ADDENDUM NUMBER 4

**LINCOLN COMPLEX – BUILDING O O.A.R., LIBRARY SERVICES AND I.T.
RENOVATIONS
930-B Oak Street SE, Albuquerque, NM 87106
ALBUQUERQUE PUBLIC SCHOOLS**

APS RFP No. 21-031-RRR

Date of Issue: 12/15/2020

APS PROJECT:
 CAD DWG FILE:
 DRAWN BY: NF
 CHECKED BY: RE
 COPYRIGHT:
 DESIGN PLUS, LLC
 SHEET TITLE
 WALL TYPES
G-103
 SHEET ___ OF ___

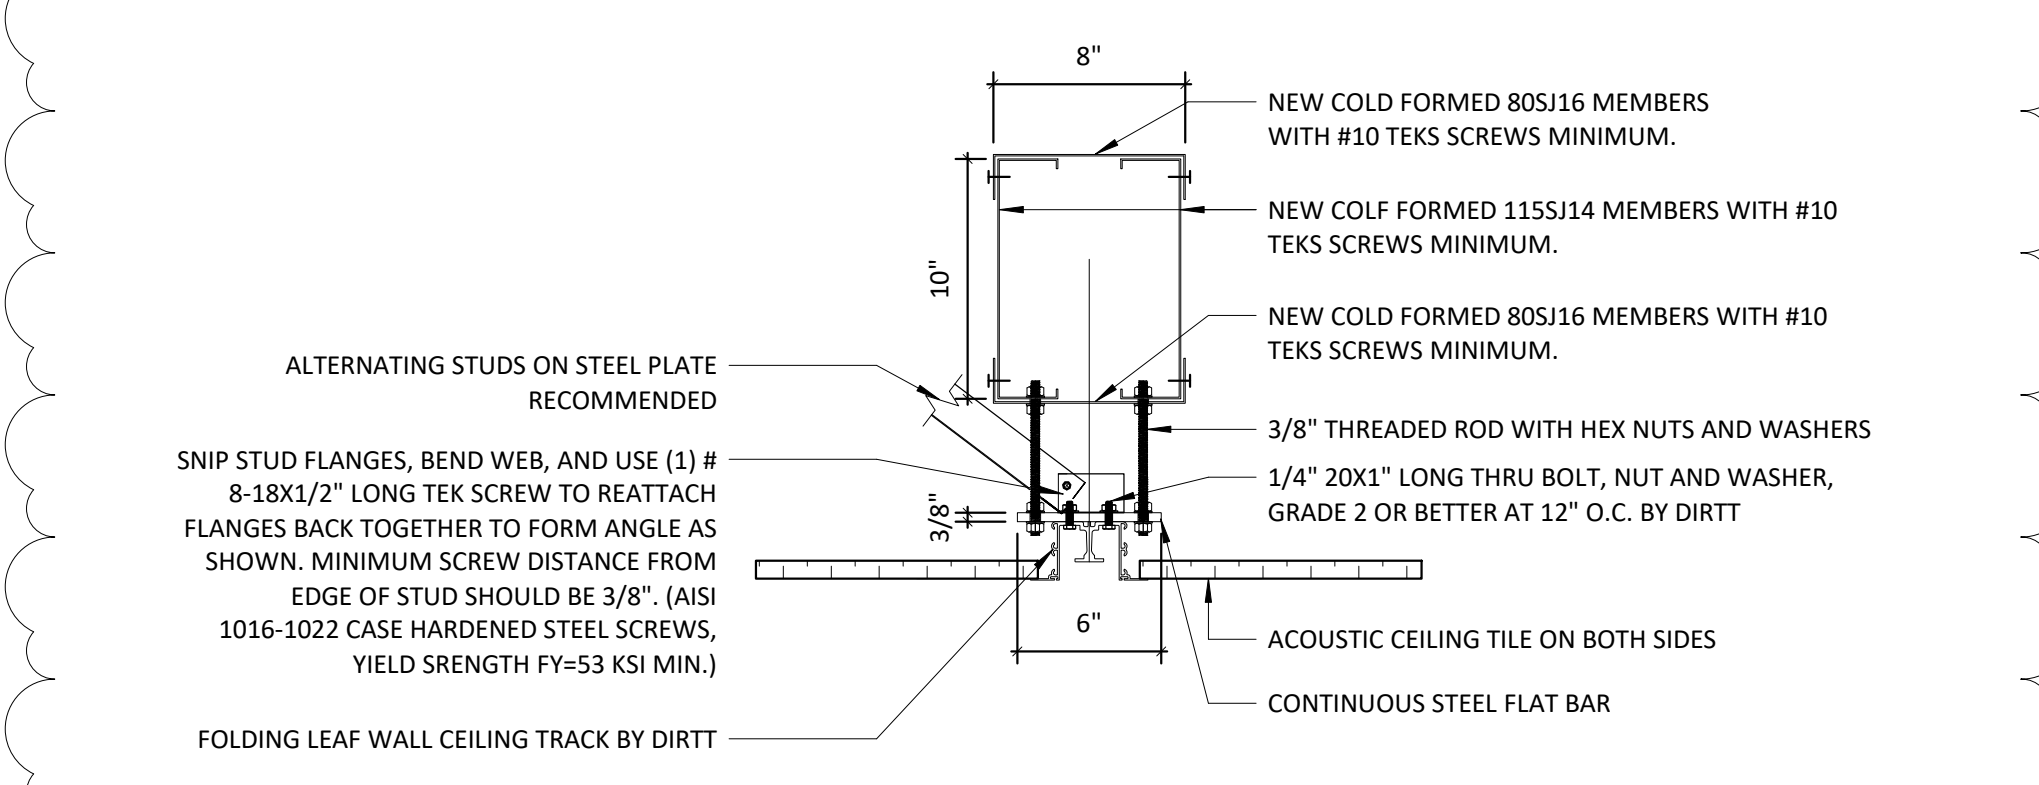
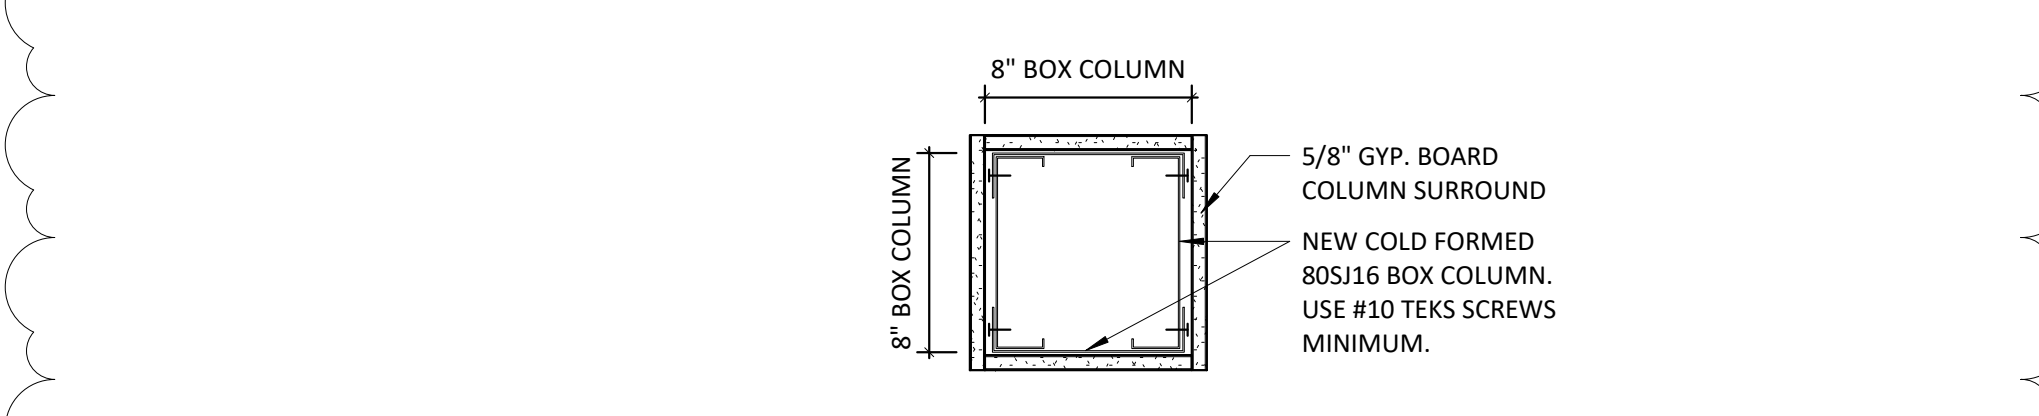
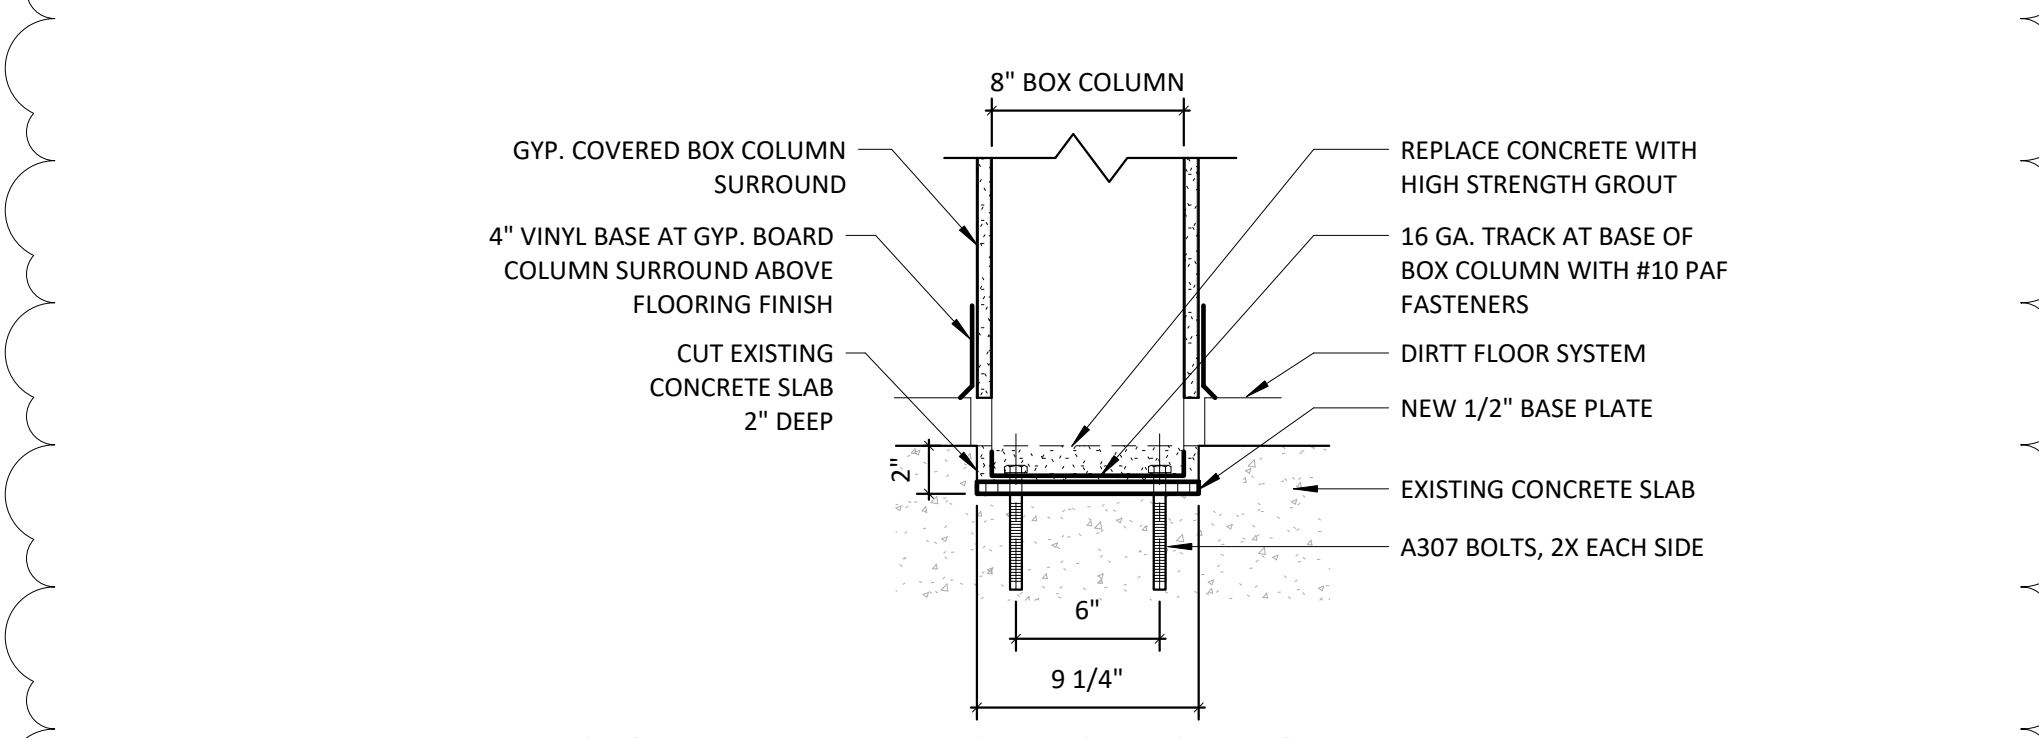
- 1) Addition: See sheet 1, 2, 3, 4/G-103 for the free standing column and header details that support the DIRTT folding leaf partition.
- 2) Addition: See 9/G-104 for the ramp section detail that will be provided by GC up to the DIRTT raised access floor system.

1 NEW KEYED FLOOR PLAN - SOUTH
1/8" = 1'-0"

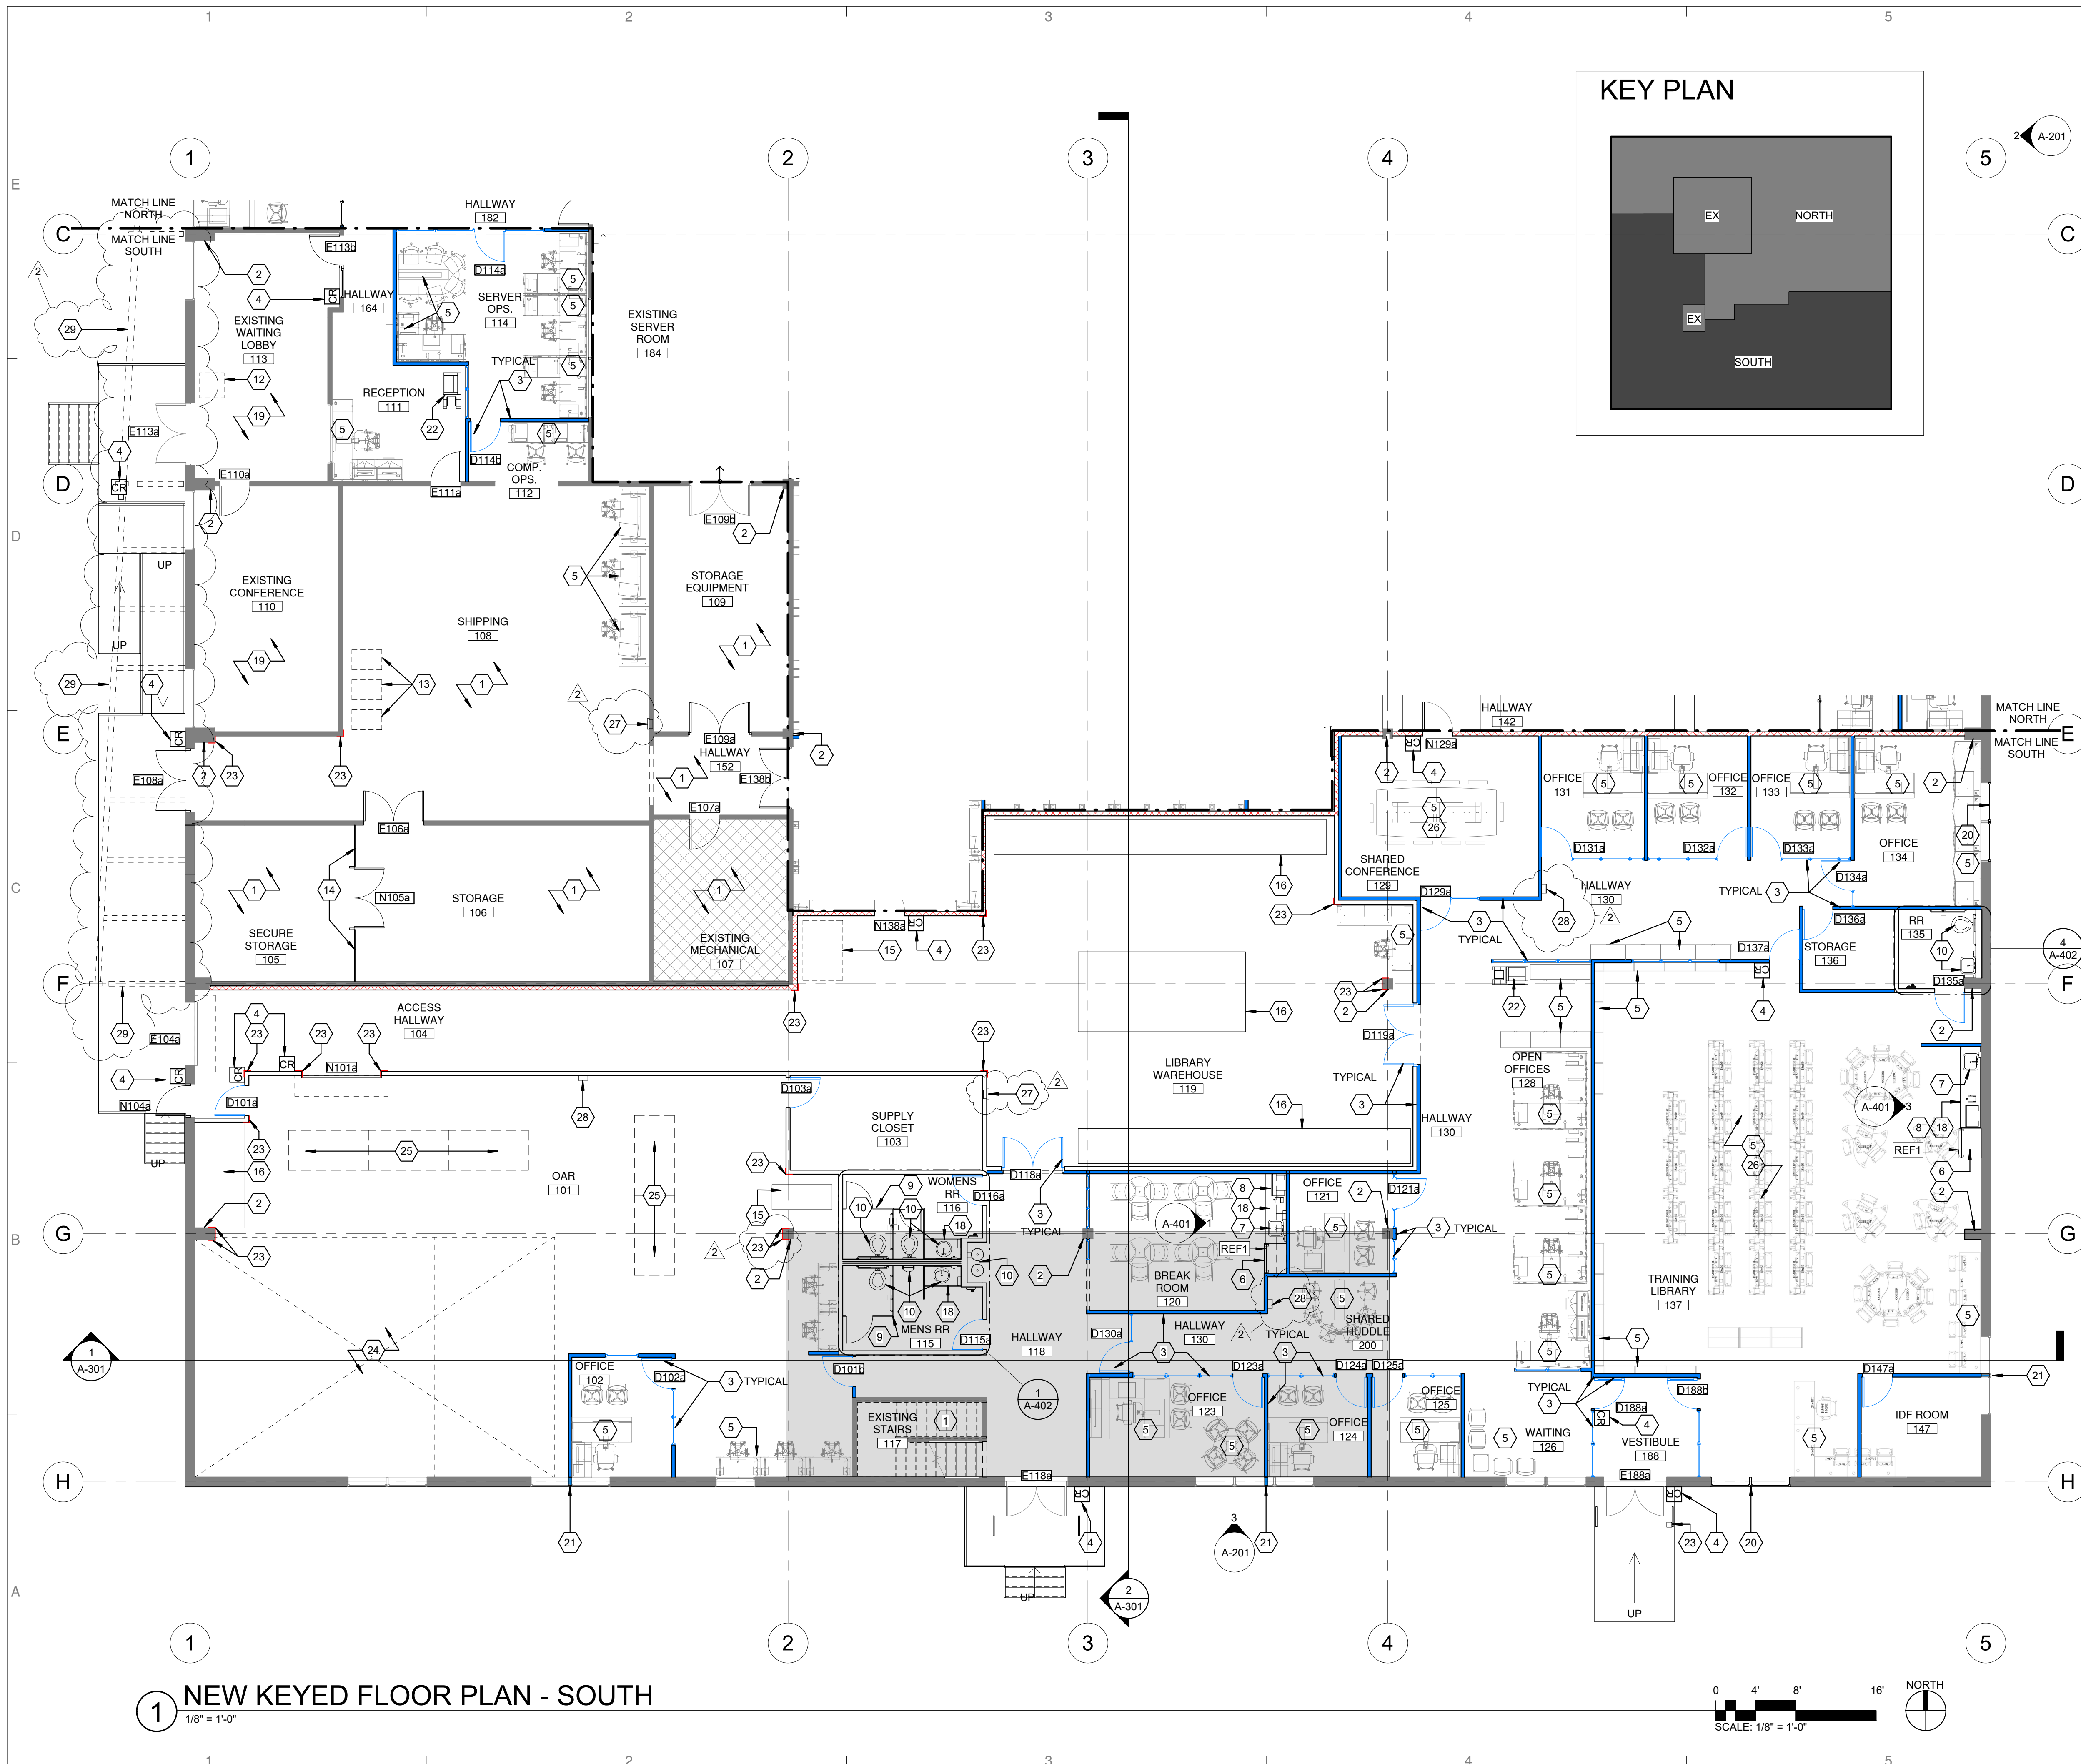
- 3) Clarification on stainless steel corner guards: sheet A-105 and sheet A-801 have been updated to reflect the same locations for corner guards and the size of the corner guards.

- 4) Clarification of existing metal canopy on west side of building: see sheet A-105 and A-107 for new keyed notes to indicate that the existing metal canopy will be included as part of Bid Lot 2 for painting.

- 5) Addition: fire extinguishers and fire extinguisher cabinets are located and noted on sheets A-105 and A-106.
- 6) Clarification: change the appliance schedule to be referenced to sheet, A-402.
